Remarks

Reconsideration of this application is requested. By this response to the Office Action dated August 26, 2004, claims 1-3 and 17-19 were amended and claims 14-16 and 20-21 were canceled. A listing of these claims and the actions taken is included in this amendment. Claims 1-3 and 17-19 remain in the application.

Figure 3

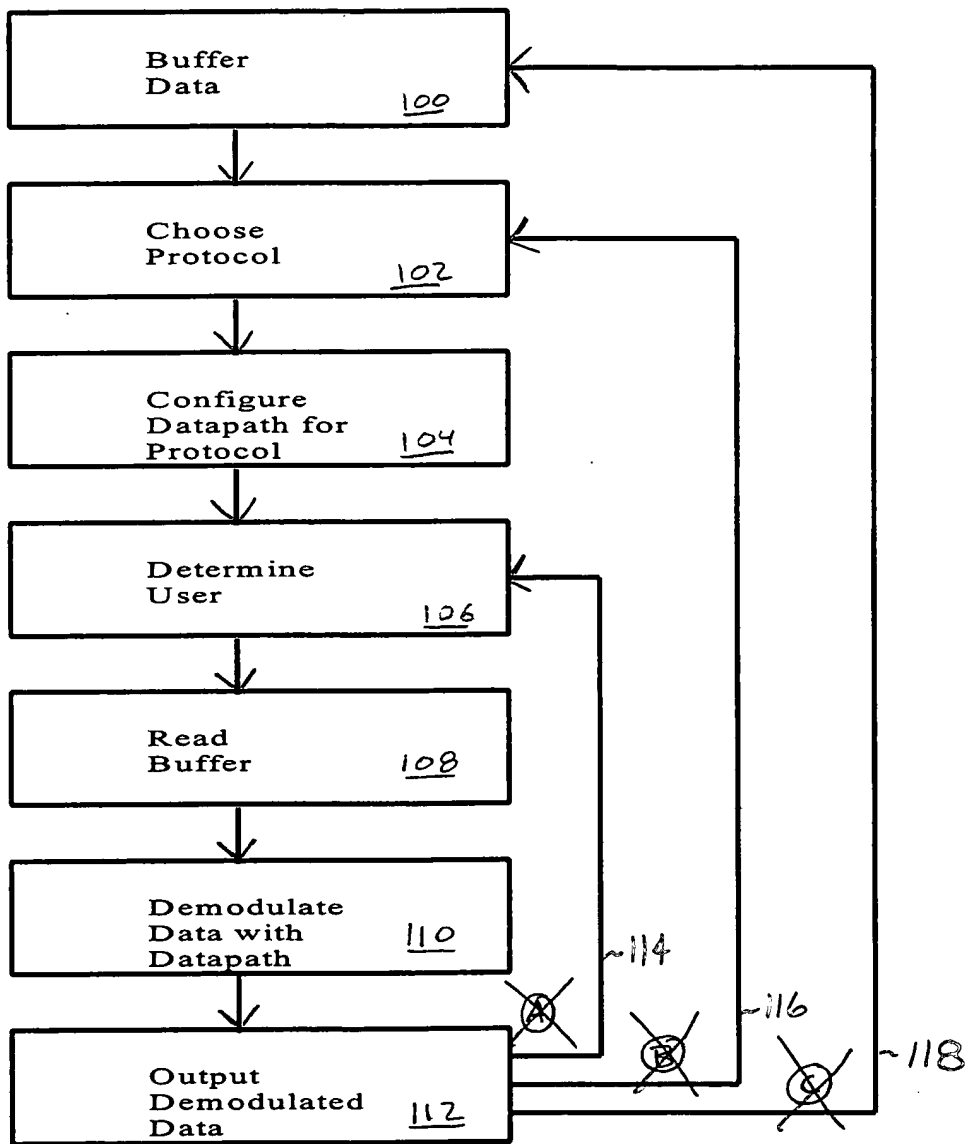
The drawings were objected to because FIG. 3 included encircled letters "A", "B" and "C". The Examiner further objected to the drawings, in particular FIG. 4, for failing to comply with 37 CFR 1.84(p)(5).

Applicants are enclosing a copy of FIGs. 1-3 with red markings to indicate proposed changes. Note that the new FIG. 3 is submitted with the encircled letters having been removed from the figure and reference numbers substituted. Also, by this amendment, FIG. 4 has been removed along with the mention of this figure in the Brief Description of the Drawings and in the specification.

Additional changes to the specification have been made to correct the use of encircled letters in FIG. 3. The replacement of encircled letters made in the figure have been also corrected in the specification.
